Technical Bulletin

HAMMOND ORGAN

SUBJECT: SWITCHING TRANSIENT ("E" SERIES)
IMPROVED BASS RESPONSE (H-100)

46 E-100, 200, 300
H-100

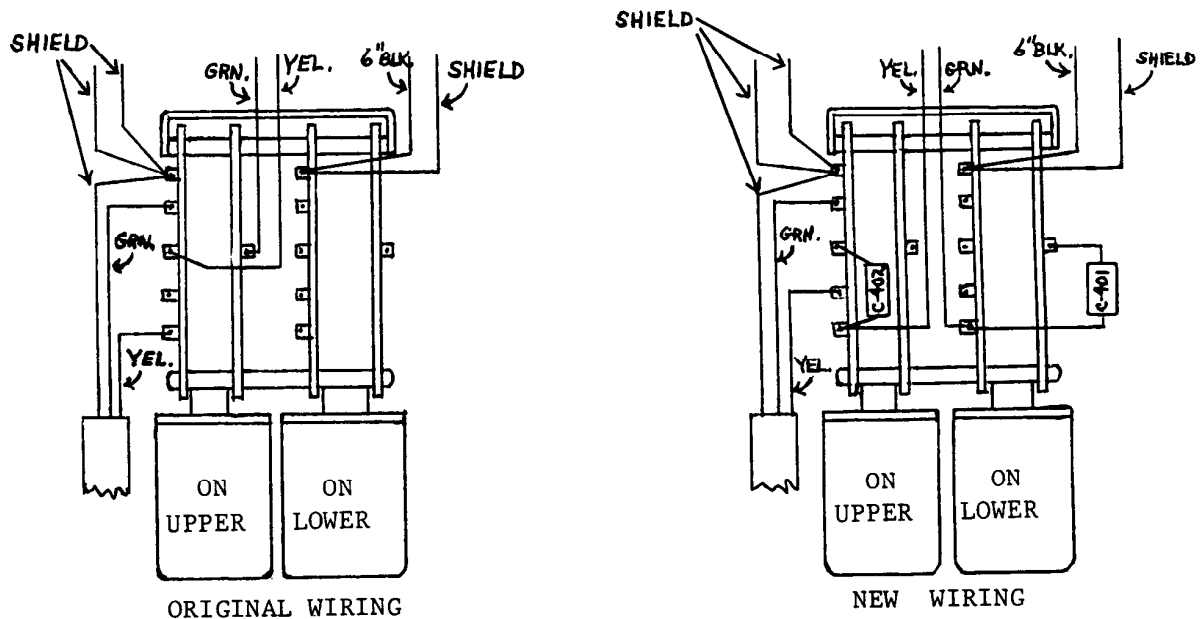
To relieve the above condition in the "Vibrato On" switches on "E" series instruments, we recommend rerouting the Yellow and Green wires going to the preamplifier, as indicated in the diagram below. To complete the circuit it will be necessary to add condensers; C-401 and C-402, .039 MFD/100 volts as indicated in the diagram below.

The drawing on the left represents the original wiring method, while the drawing on the right represents the above changes.
